BROWNS FERRY NUCLEAR PLANT (BFN) – UNITS 1, 2, AND 3 - TECHNICAL SPECIFICATIONS (TS) CHANGES TS-431 AND TS-418 – EXTENDED POWER UPRATE (EPU) – RESPONSE TO ROUND 19 REQUEST FOR ADDITIONAL INFORMATION (RAI) (TAC NOS. MD5262, MD5263, AND MD5264)

TENNESSEE VALLEY AUTHORITY
BROWNS FERRY NUCLEAR PLANT (BFN)
UNITS 1, 2, AND 3

RESPONSE TO ROUND 19 REQUEST FOR ADDITIONAL INFORMATION (RAI)

Figure EMCB.183-1g: Accumulative alternating stress intensity curves for node 104539

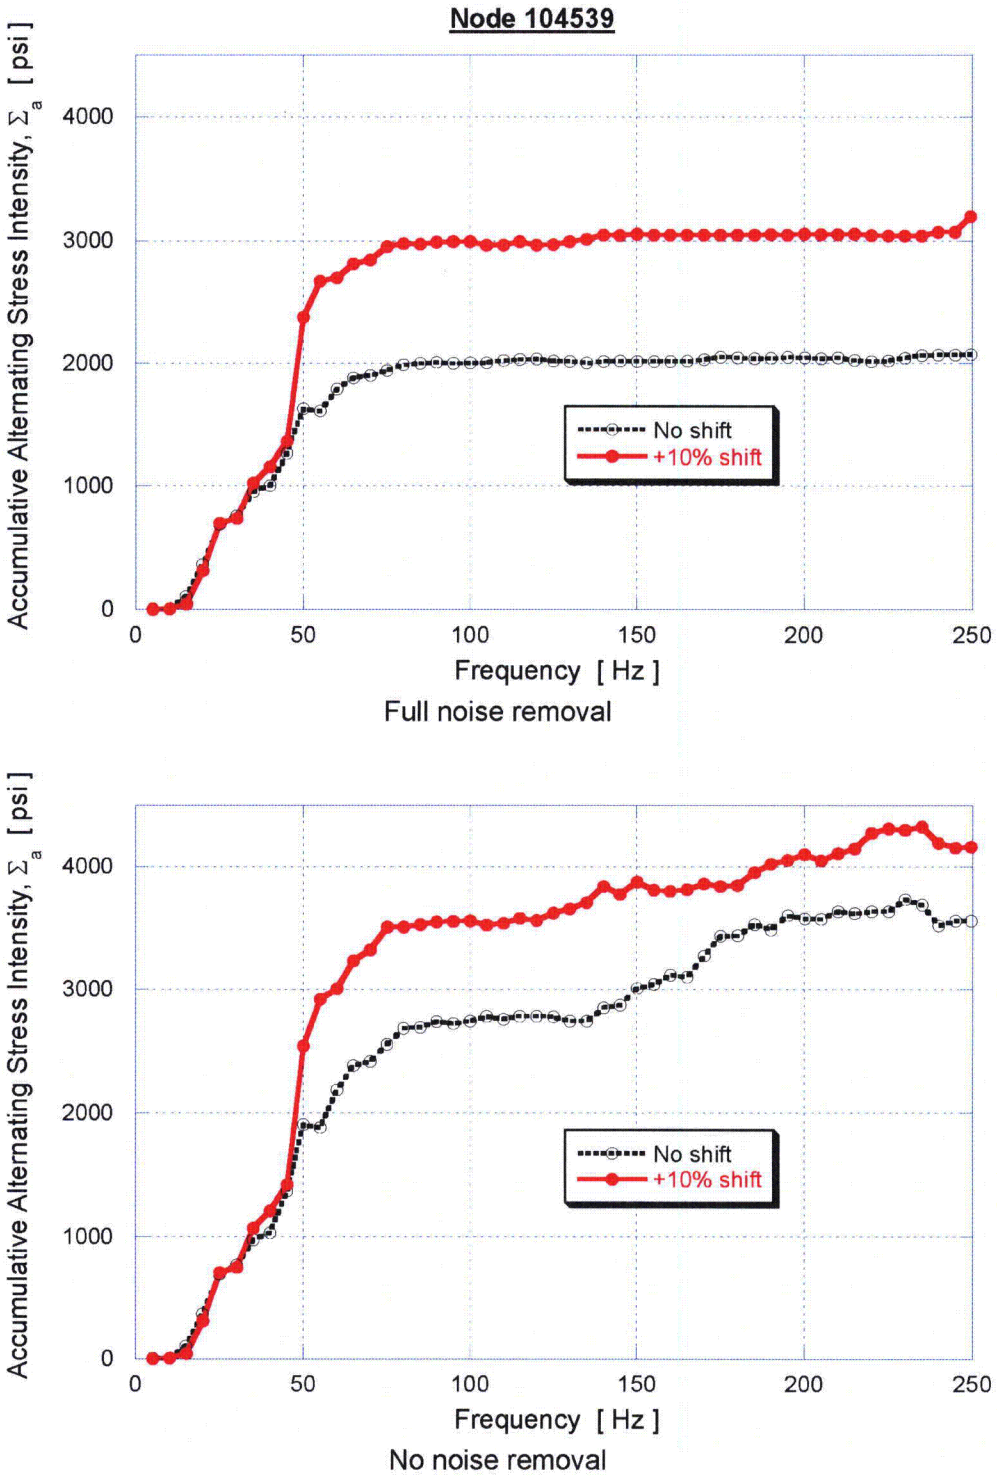
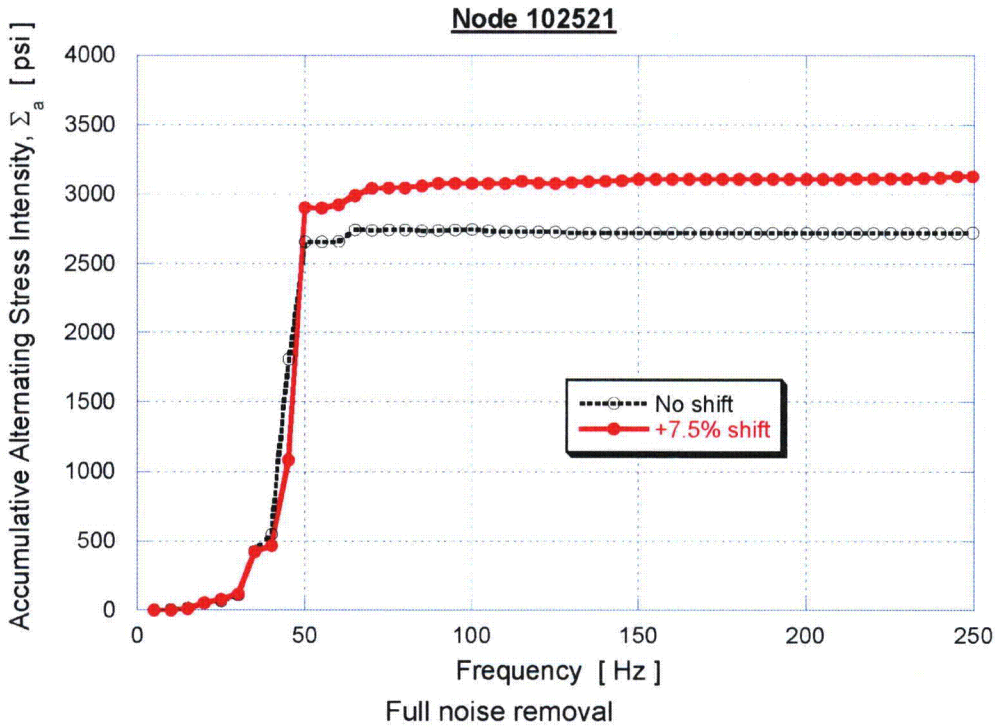
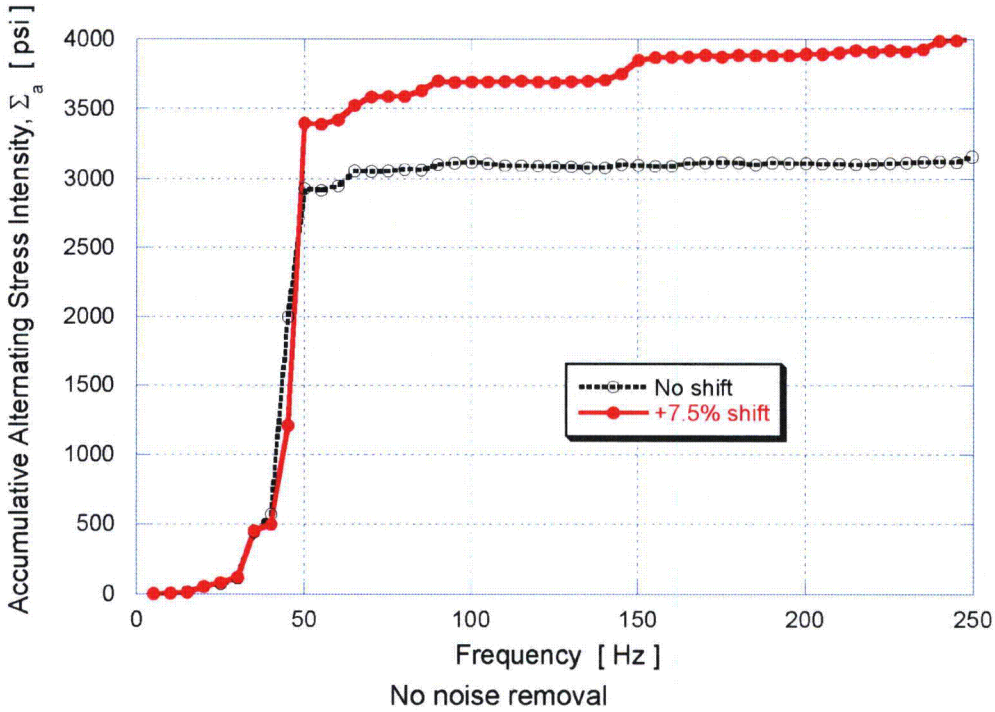
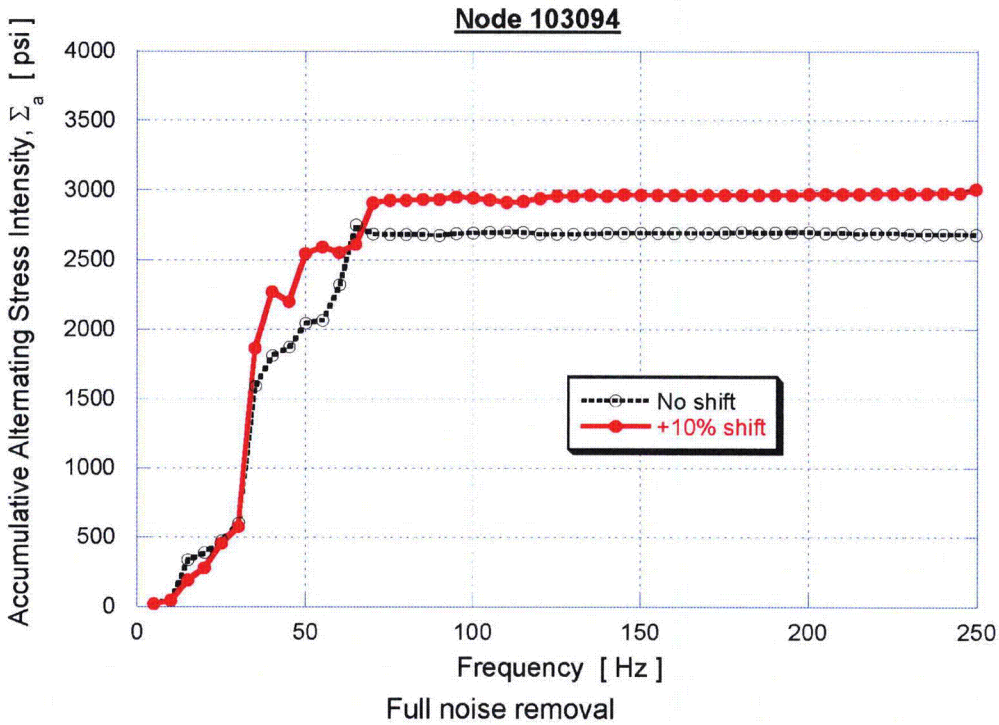
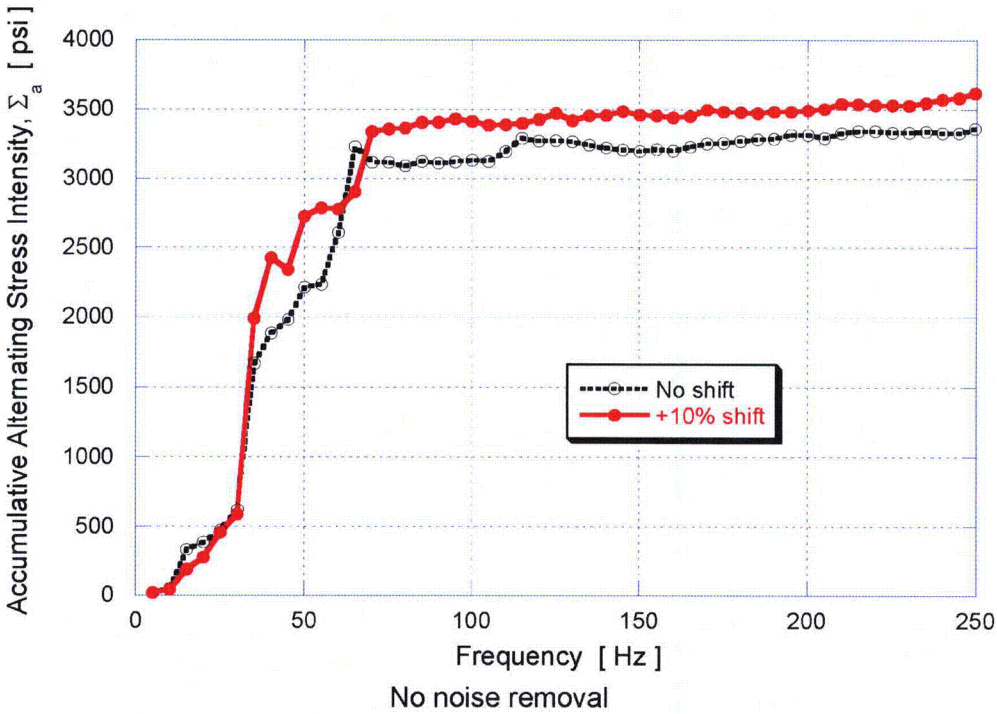
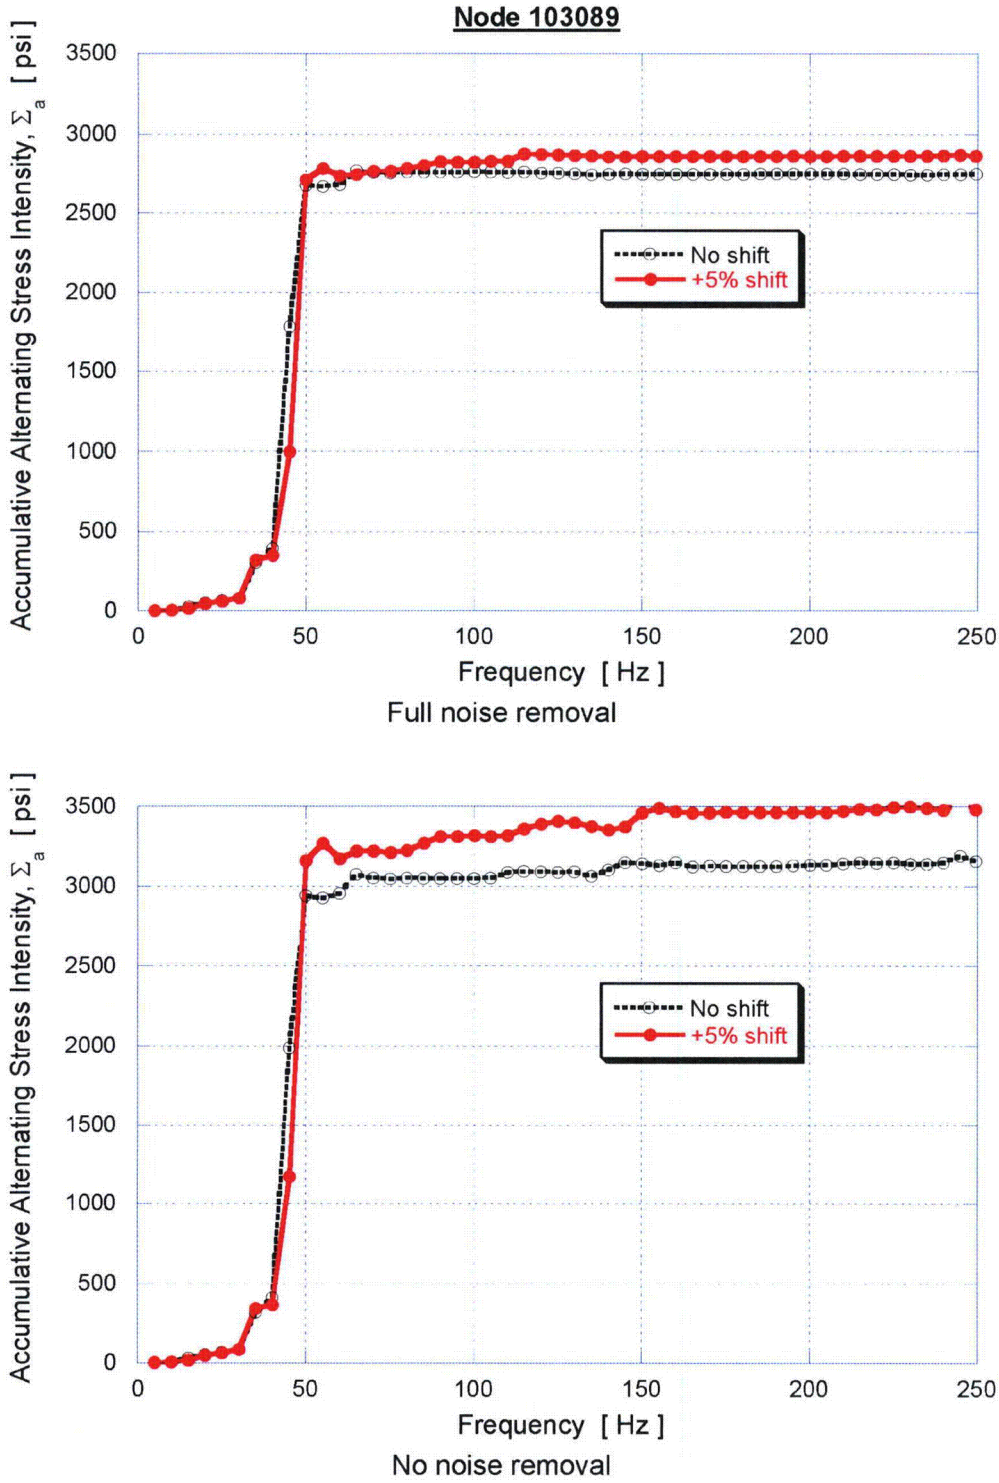
The accumulated stress plots presented in response to RAI EMCB 170/138 show that the alternating stress amplitude increases little beyond 100 Hz. Please explain this observation. Provide similar stress plots when unfiltered MSL signals are used for the stress analysis of Unit 1 dryer. Please explain the differences between the plots for filtered and unfiltered signals.

Figures EMCB.183-1a through j shows the accumulative stress intensities without noise removal. To facilitate comparison, the accumulative alternating stress intensities presented in the response to RAI EMCB 170/138 using noise removal algorithm (i) above are also shown. As before, the accumulative alternating stress intensity, $\Sigma_a(f)$, is defined as the alternating stress computed when zeroing all stress harmonics for frequencies above f. It is computed in 5 Hz increments as explained in the response to RAI EMCB 170/138.

In all cases, with or without noise removal, the dominant increases in the accumulative alternating stress intensity occur below 100 Hz. With noise left in, node 104539 exhibits the strongest increase above 100 Hz, though still less than the rise below 100 Hz. At the worst case frequency shift (+10%) for this case, the increase in alternating stress intensity between 0 to 100 Hz is 3560 psi. The remaining increase above 100 Hz is 604 psi, or less than 17% of the 0-100 Hz rise. The other node with a significant increase above 100 Hz is node 102407 which shows a jump at approximately 120 Hz. The total increase for this node (noise left in and the worst case frequency shift of +2.5%) above 100 Hz is 703 psi which is 14% of the 0-100 Hz stress rise (4955 psi).

The differences between the filtered and unfiltered stress responses can mostly be attributed to higher rises (with noise left in) in the 35-65 Hz range. This is consistent with the fact that the noise removal algorithm reduced the signal amplitude where the noise is high. These reductions are quantified in the response to RAI EMCB 170/138.
